<input type="checkbox"/> Sidewalk Waiver (Form V2)	<input type="checkbox"/> Sketch Plat Review and Comment (Form S2)	
<b>SITE PLANS</b>			
<input checked="" type="checkbox"/> DRB Site Plan (Form P2)	<input type="checkbox"/> Waiver to IDO (Form V2)	<b>APPEAL</b>	
	<input type="checkbox"/> Waiver to DPM (Form V2)	<input type="checkbox"/> Decision of DRB (Form A)	
<b>BRIEF DESCRIPTION OF REQUEST</b>			
Minor Amendment to Approved Site Plan (Form P3)

**Re: Summary of Modifications to Site Plan to Meet DRB Conditions of Approval for Issuance  
of Certificate of Occupancy  
5710 Avalon Rd NW – Generations at West Mesa Development  
BP-2018-07324**

**GENERATIONS AT WEST MESA**  
57TH STREET AND CENTRAL AVE  
ALBUQUERQUE, NM

**SITE DEVELOPMENT  
PLAN FOR BUILDING  
PERMIT**

**C1 SITE PLAN**  
1" = 30'-0"  
0 30' 60'

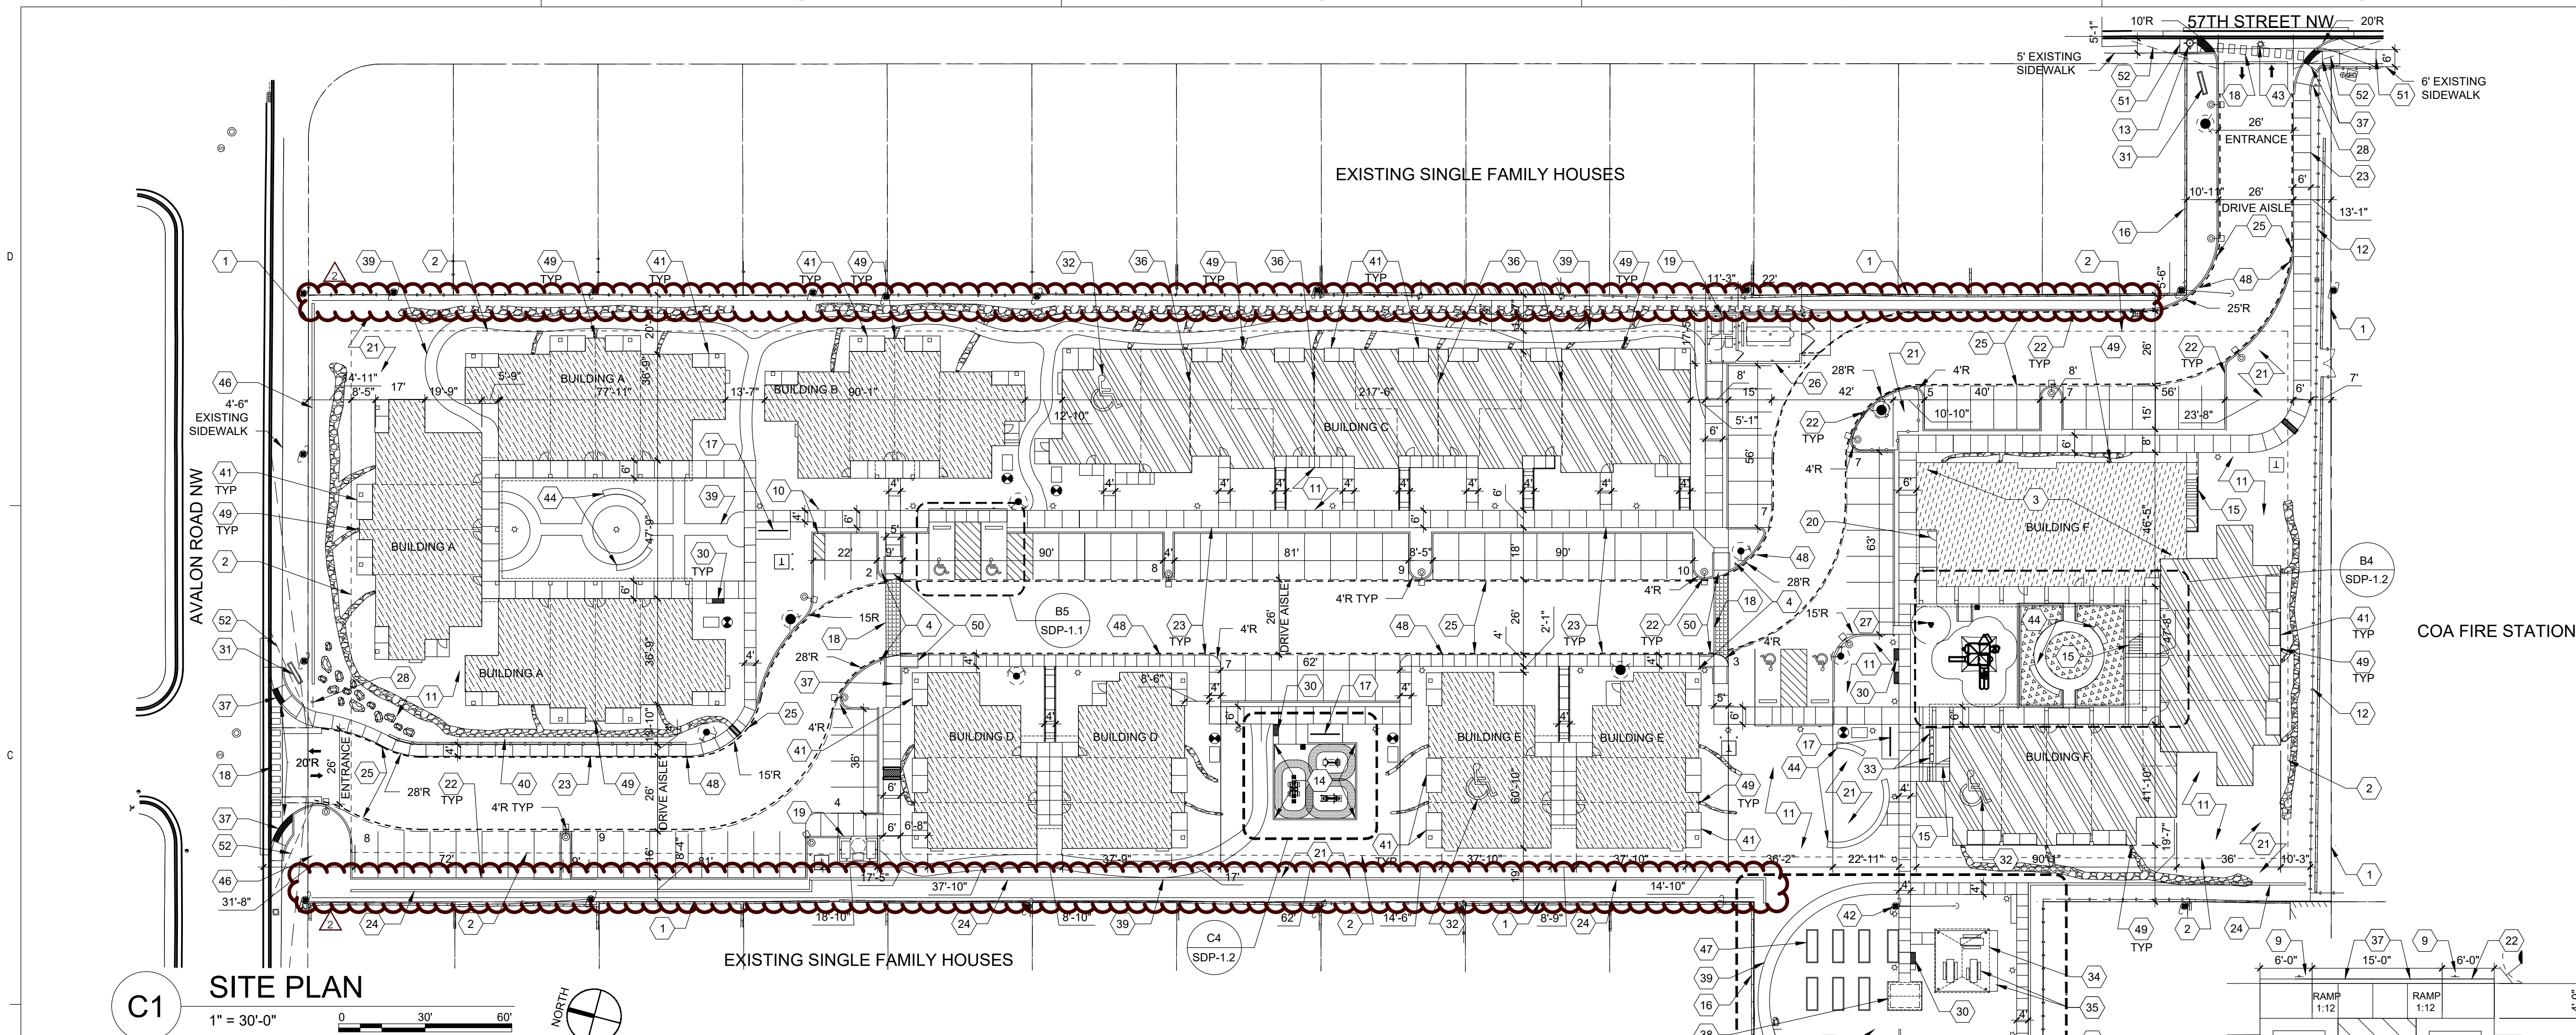
During construction of the Generations at West Mesa development, site constraints complicated site construction that necessitated deviations from the approved DRB Site Plan. The east retaining wall was removed and the west retaining wall was changed to a 4' retaining wall. Per IDO Section 6-4(Y)(1)(a), the applicant will submit a Minor Amendment to the approved January 2016 DRB Site Plan to satisfy Code Enforcement violation received March 05, 2020.
